## MEMORANDUM

To: David E. Griffith, PE  
 From: Reneé Whittenberger, PE, RSP1 and Sela Jones, EIT  
 Date: January 30, 2025  
 Subject: Addendum to Report Recommendations

Upon providing a schematic plan of proposed countermeasures in the *TRU-SR 193-1.67 Roadway Segment Safety Improvement Study*, project team members met with stakeholders to gather feedback prior to the request of implementation funding. The following recommendations were provided in the report:

Upon receiving input from members of the Township, the project team has created a revised plan of proposed countermeasures which is to be utilized for the request of implementation funding. These changes are clarified herein:

Proposed Safety Improvements

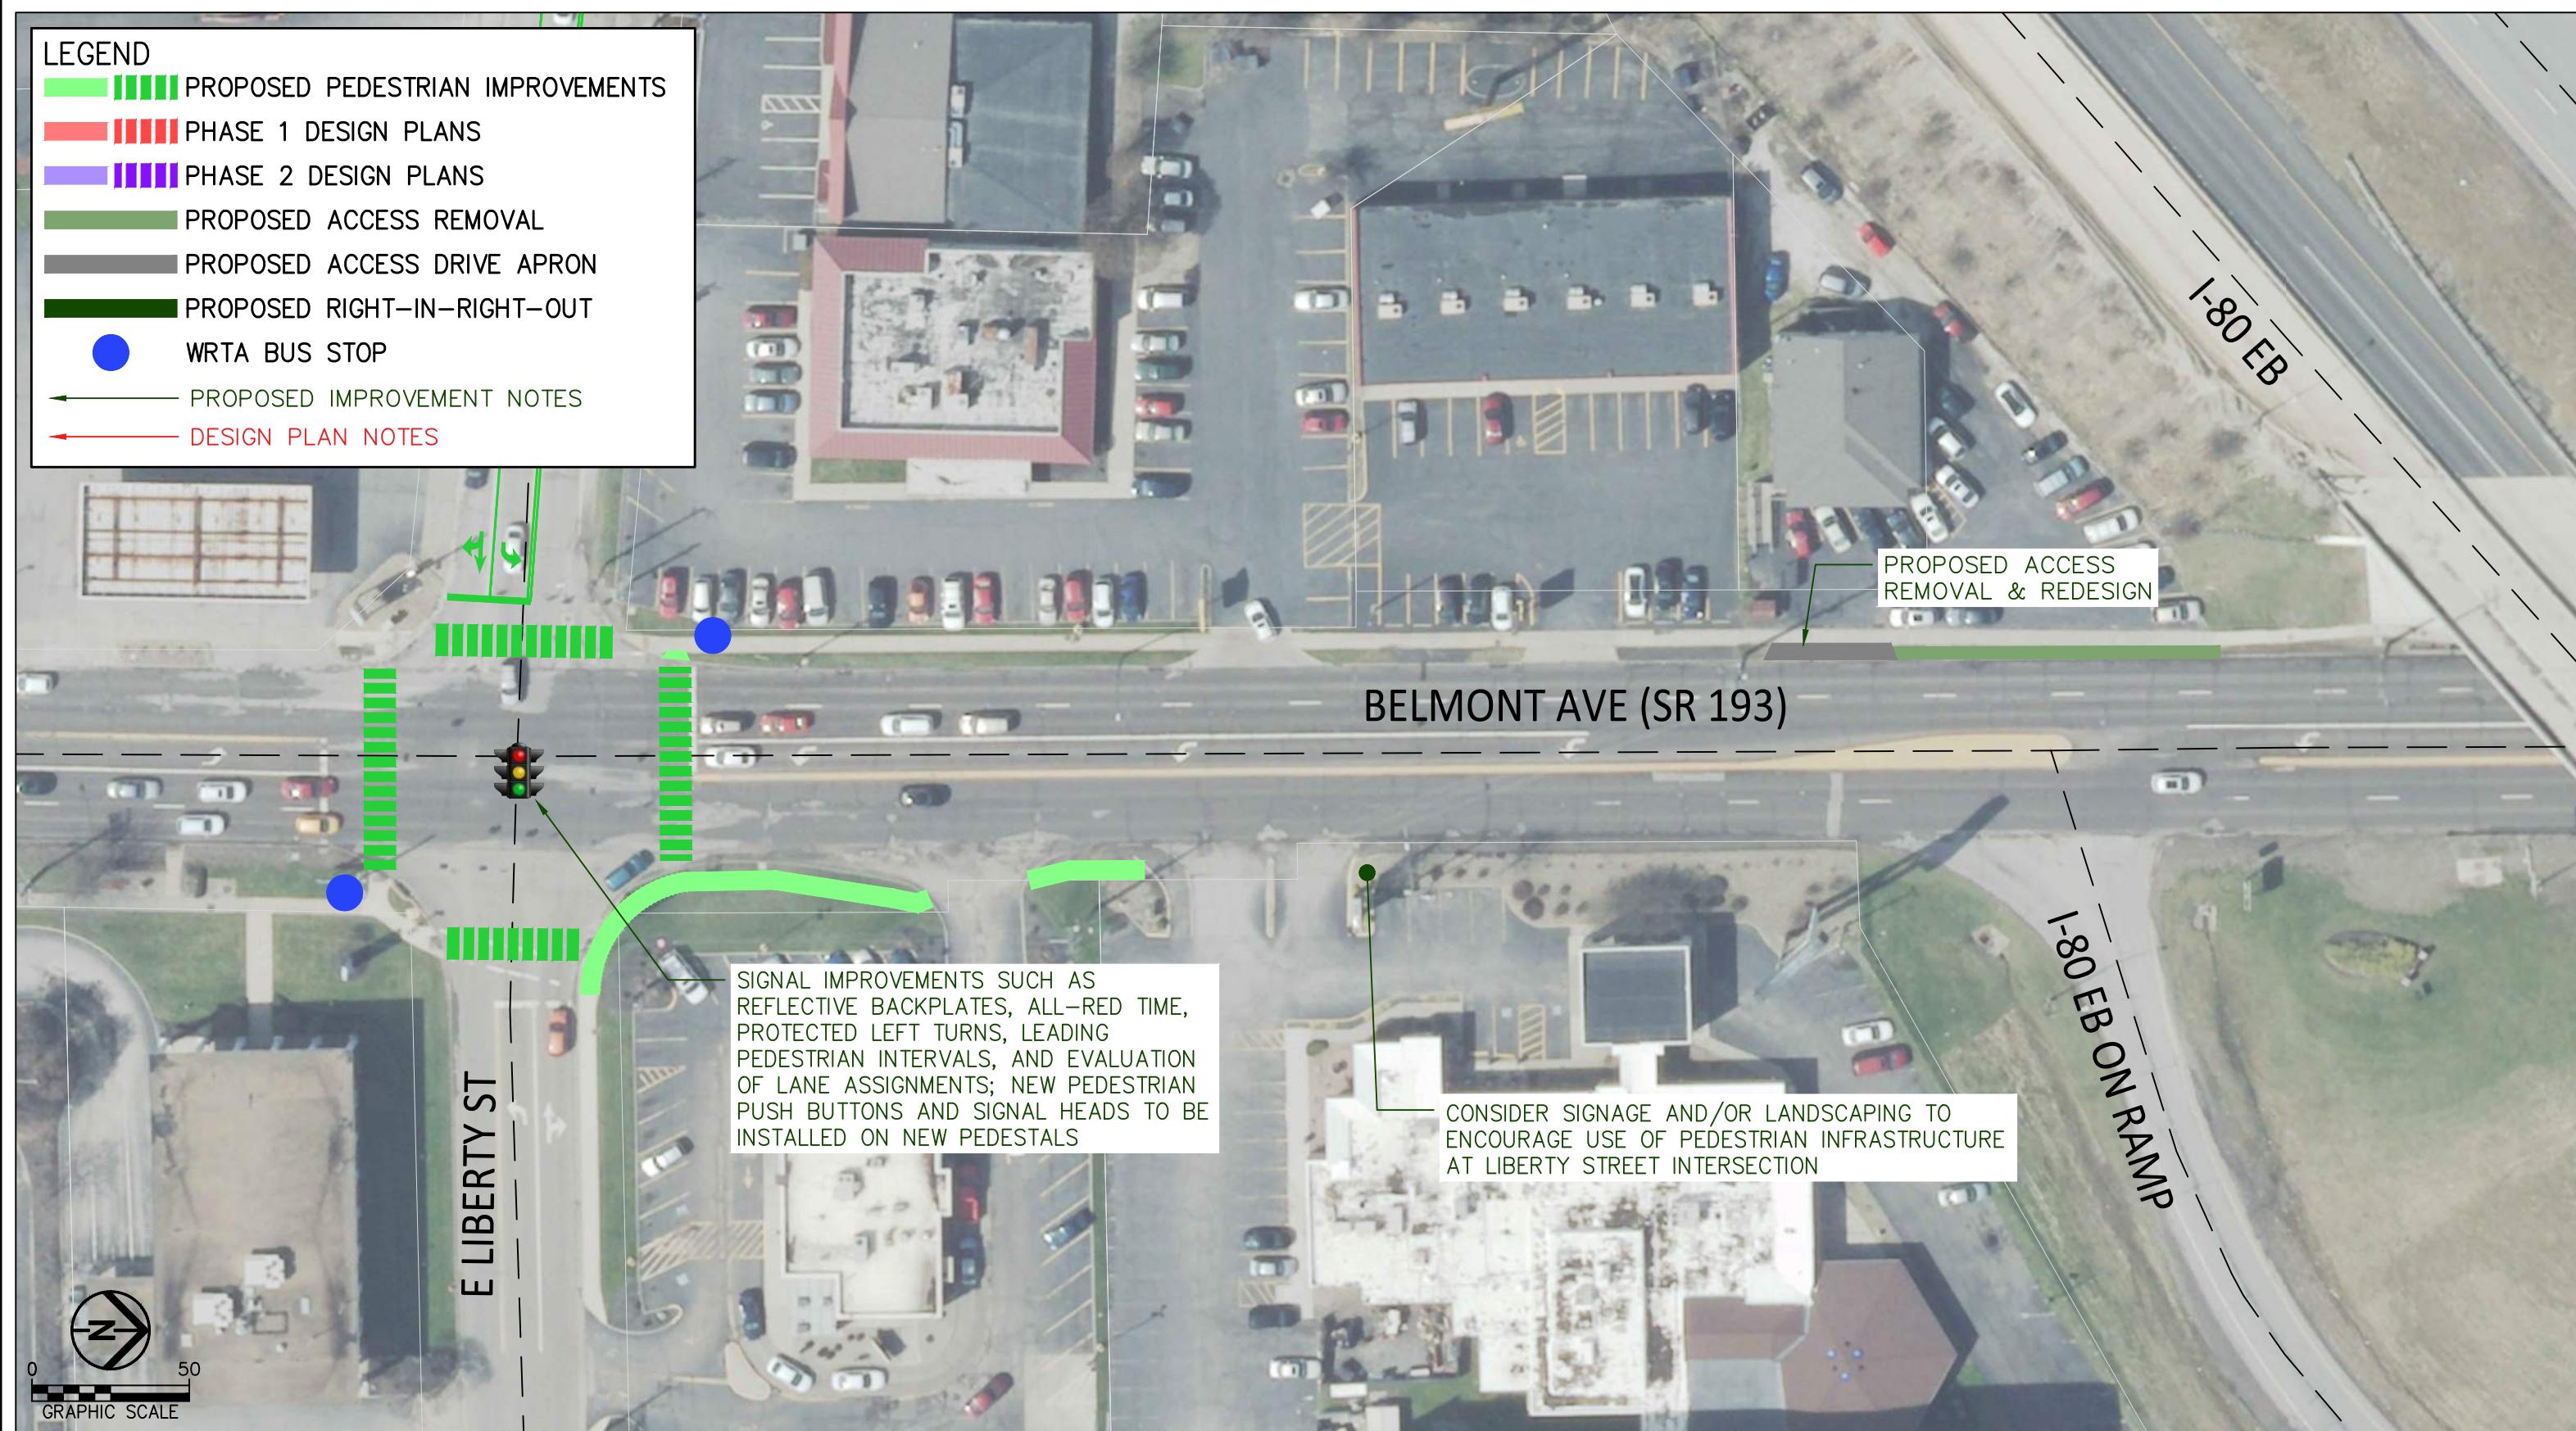
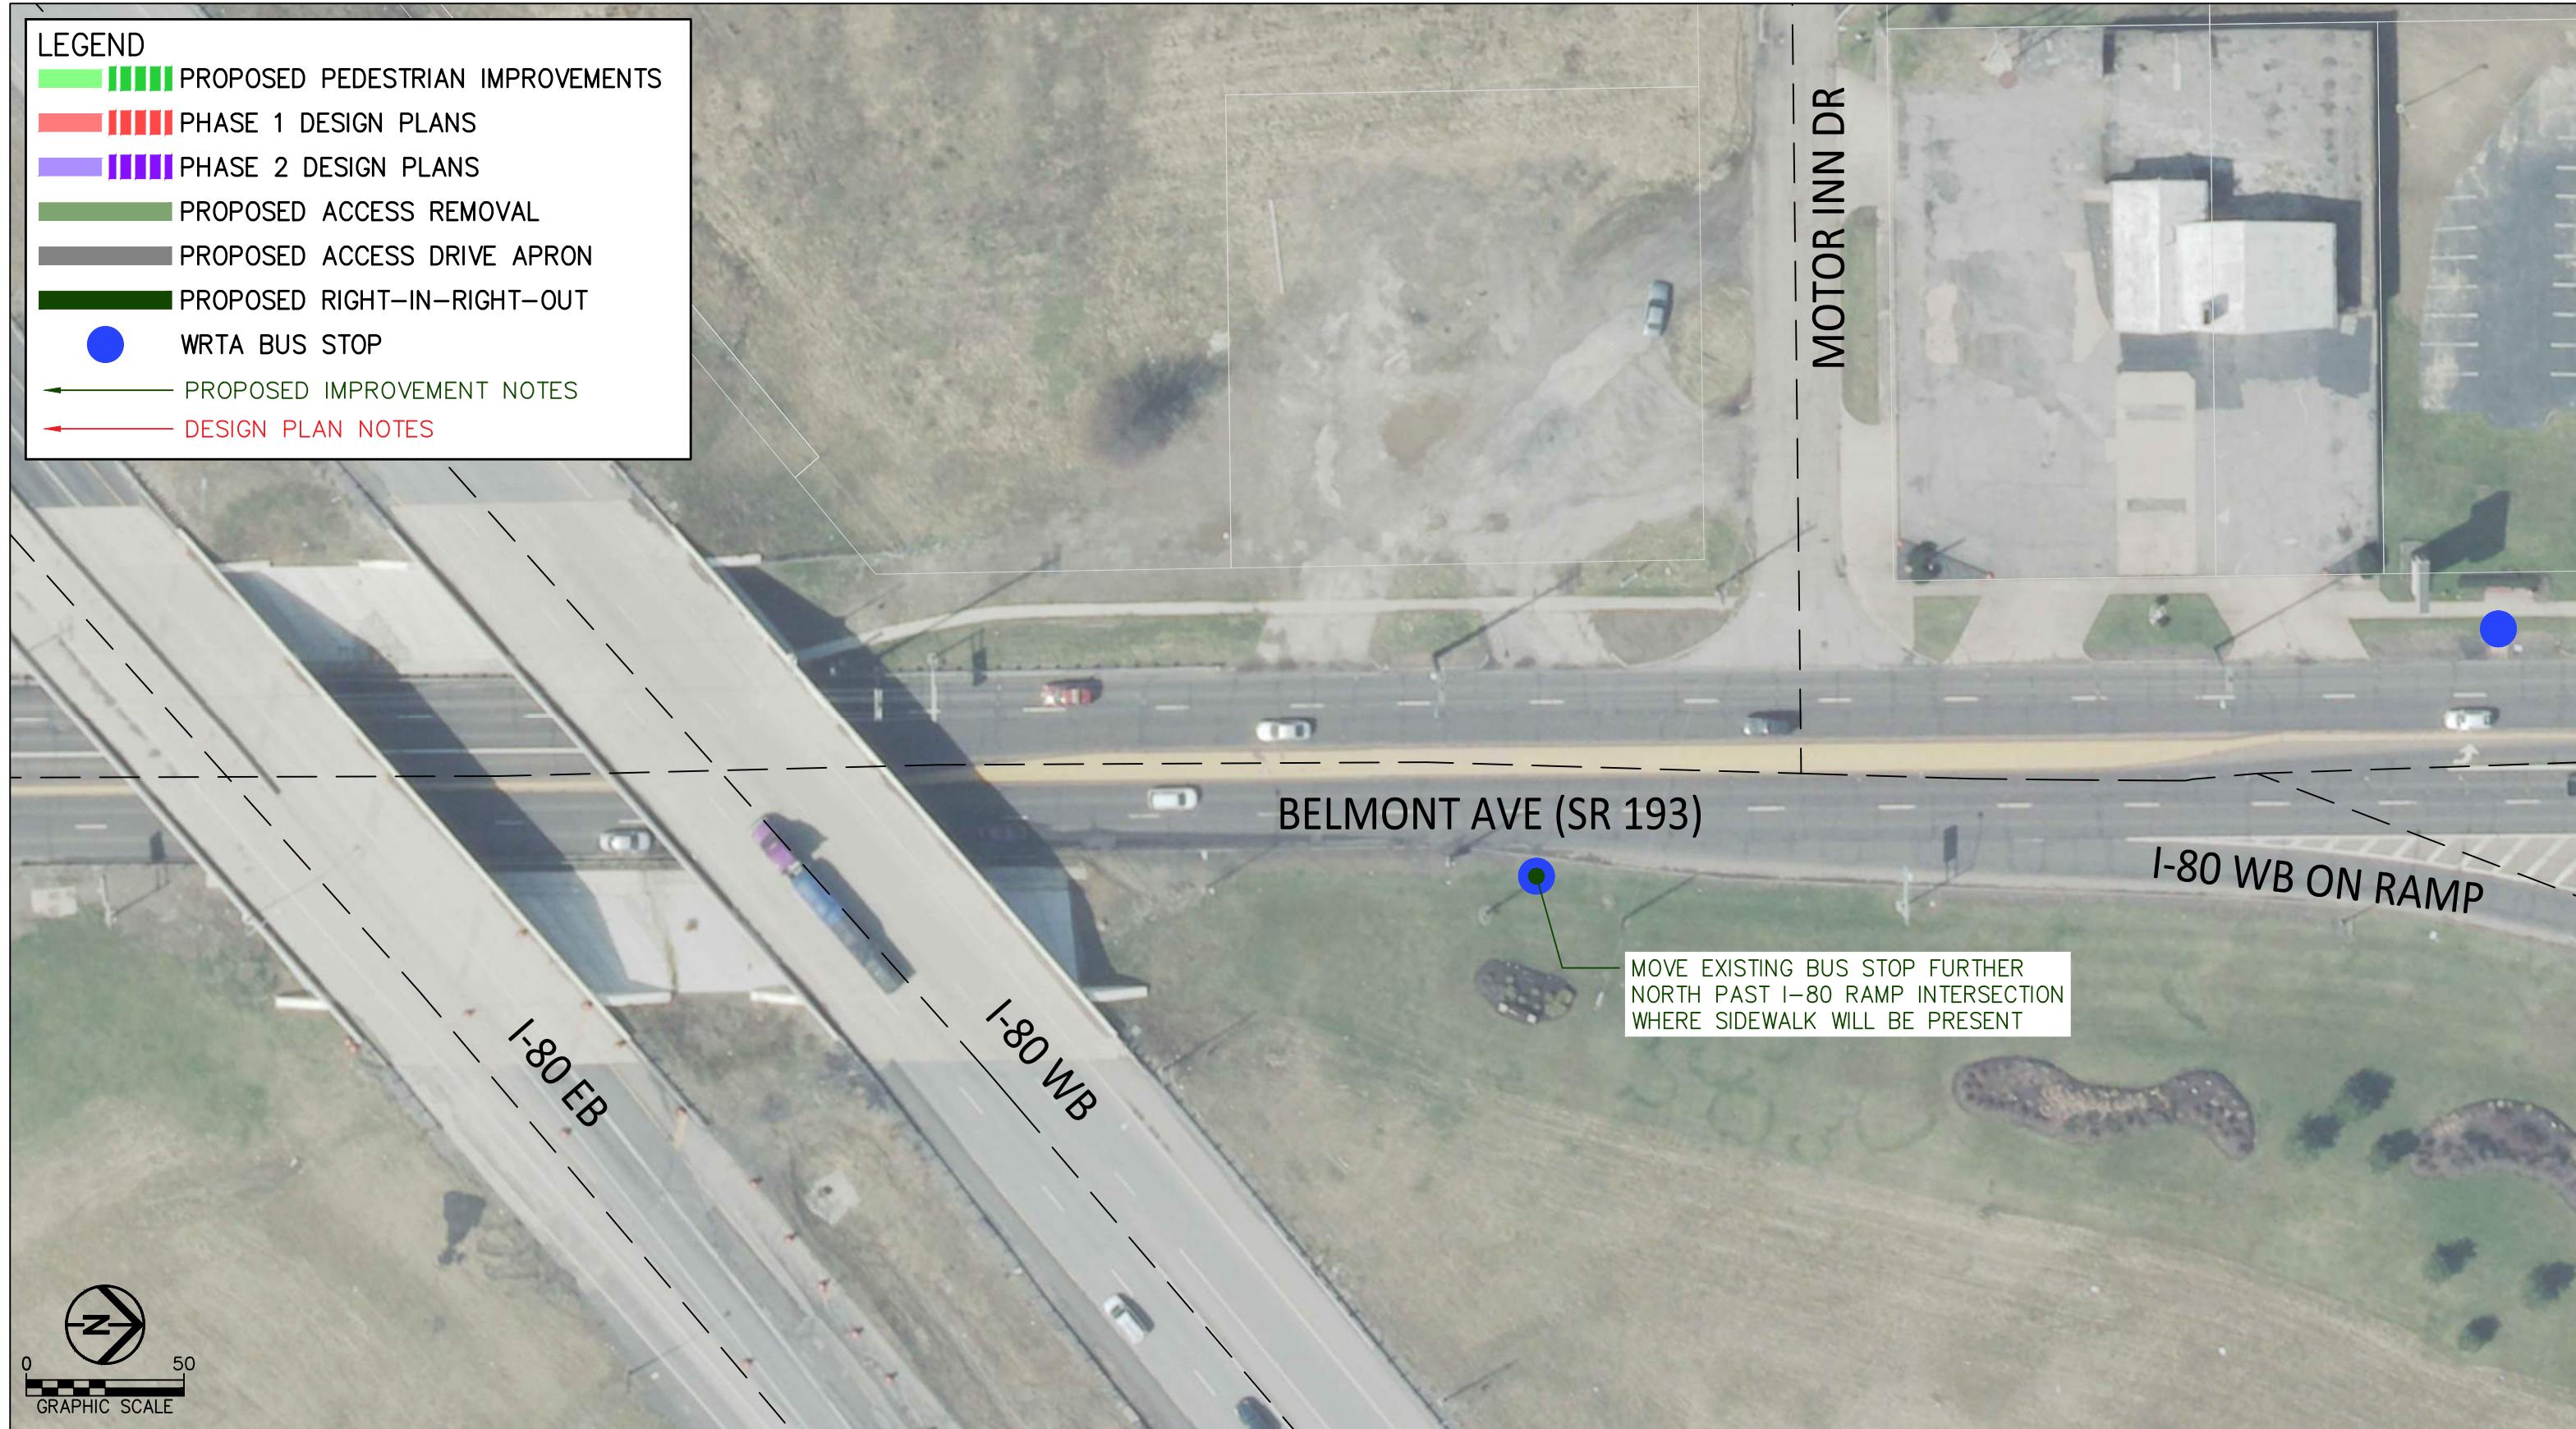
- Members of the Township expressed disinterest in providing sidewalk on the east side of SR 193 in proximity to the I-80 overpass, due to concern that the proposed infrastructure will encourage pedestrian activity near high-speed vehicles preparing to enter I-80. This includes the eastbound ramp south of the overpass and the slip lane which transitions into the westbound ramp north of the overpass. Presently,

the only amenity for pedestrians in this area is the *Belmont Avenue & Motor Inn Drive WRTA* bus stop. Stakeholders discussed their interest in moving this bus stop north of the westbound I-80 ramps in hopes of discouraging pedestrian traffic in the vicinity of high-speed vehicles preparing to enter I-80. This feedback has resulted in the removal of proposed sidewalk, crosswalks, and a rectangular rapid flashing beacon (RRFB) in this area. As a result, **the new sidewalk on the east side of SR 193 is now proposed to begin at Liberty Street and end at the entrance to the Baymont by Windham entrance.**

- Members of the Township expressed disinterest in removing access at the Speedway gas station across from the westbound I-80 ramps, due to the concern that incoming trucks will lose the ability to maneuver into the establishment. Also, the existing access point contains a median which facilitates right-in right-out movements. The project team agrees that this entrance can remain in its existing configuration. As a result, **access removal at the Speedway entrance is no longer proposed.**

- Members of ODOT District 4 expressed concern over the access management proposed for the restaurant property on the west side of SR 193 south of the I-80 overpass. Due to the multiple existing access points at the property, which increase exposure for crossing pedestrians, project team members recommended one shorter access point available at the north end of the lot. However, ODOT District 4 was concerned over the possibility of exiting patrons' ability to cross five lanes of traffic through the gap in the median in hopes of traveling northbound on SR 193 or entering the eastbound I-80 ramp. As a result, **the new access point of the restaurant property south of the I-80 overpass is now recommended for the south end of the lot, as this configuration utilizes the existing median to limit movements to right-in right-out only.**

- In the interest of maintenance and cost, **replacing the median** between the I-80 overpass and the I-80 westbound ramp intersection **was not preferred. The existing median will remain.**
